JOHN AND DEBRA WILLIAMS
SUBDIVISION

FINAL PLAT

Re: S/D 96-52 - JOHN AND DEBRA WILLIAMS ADDITION (Final Plat)

CASE NUMBER: S/D 96-52 JOHN AND DEBRA WILLIAMS ADDITION

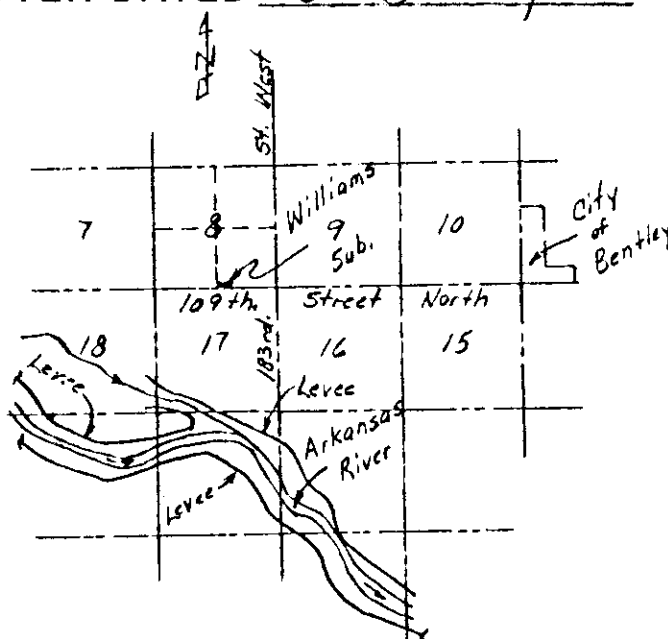
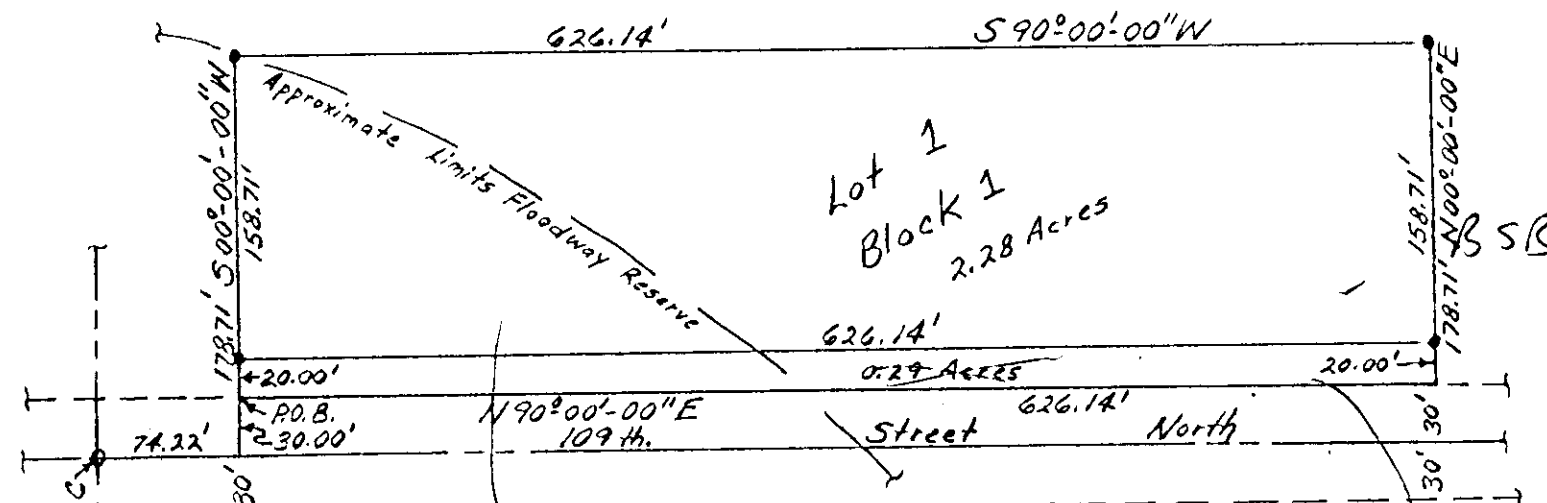
Flowway long - M. or P. - Clearly Note R.O.W. do not on solid - Delete .294 sq row - AC

- ~~**D.**~~ On the final plat tracing, the face of the plat shall clearly label the area of street dedication and this area shall be shown in a more specific manner from the adjoining lot. Dashed lines, fainter lines, etc. should be used for the 20-foot dedication so as to make it distinctly separate from the adjoining lot. The .29 Acre noted in the area of dedication shall also be deleted.

- ~~**E.**~~ The final plat tracing shall indicate a 30-foot building setback to 109th Street North.
- ~~**F.**~~ The face of the plat shall also note the dedication of the access control as stated in the platlor's text.

- G. On the final plat tracing, a tie point shall also be shown on the face of the plat.
- H. The final plat tracing shall indicate a minimum building pad elevation as required by County Engineering. Both the plat's text and face of the plat shall note such an elevation. Also, both an on-site and off-site benchmark shall be shown.
